MITSUBISHI HEAVY INDUSTRIES, LTD.
16-5, KONAN 2-CHOME, MINATO-KU
TOKYO, JAPAN

Docket No. 52-021
MHI Ref: UAP-HF-09196

Subject: MHI's Responses to US-APWR DCD RAI No.229-2022, No.226-2018, No.230-2028, No.227-2020, No.238-2030, No.239-2033, No.240-2035, No.228-2021, and No.231-2037, Revision 0

RESPONSE TO REQUEST FOR ADDITIONAL INFORMATION

Figure 7.5-4 Alarm System Configuration

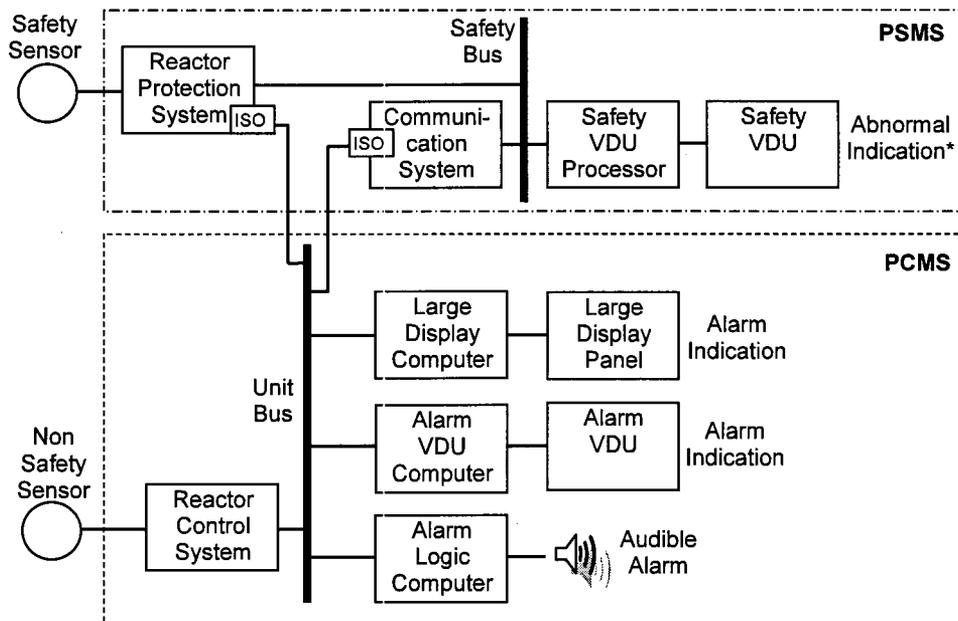
The alarm system configuration including alarms credited for manual actions in safety analysis with safety sensors and non-safety sensors are shown in Figures 7.5-4. In addition to the sufficient reliable PCMS alarm, the parameters for credited manual operator actions are indicated on safety VDU to accommodate degraded HSI conditions (i.e., loss of PCMS VDUs). Restricted, continued operation with complete loss of PCMS VDUs is within the US-APWR HSI design basis. Indications on the safety VDU are spatially dedicated and continuously visible (SDCV), which enables notification of the plant accident condition to the operator in case of malfunction of PCMS VDUs.

Figure 7.5-4 will be added as follows.

*1 Alarms to prompt credited manual actions in safety analysis are indicated on the safety VDU as abnormal indications.

safety system and non-safety system via the unit bus as illustrated in Figure 7.5-4. This communication meets the requirements of DI&C-ISG-04. More detail for the unit bus is described in Subsection 7.9.1. The alarm VDU computer and all alarm HSI components, including audible and visual devices, are redundant to ensure operation is not adversely affected by credible malfunctions. The alarm system integrity is checked by self-diagnosis which does not affect alarms and digital control system portion of alarms that have self-diagnosis functions. Alarm signals originate in plant instrumentation or within the controllers of the PCMS and PSMS. These signals are interfaced to the PCMS via the redundant unit bus, described in Section 7.9. The data interface to the PSMS is physically and functionally isolated so as not to affect the safety system in case of failure of the alarm system.
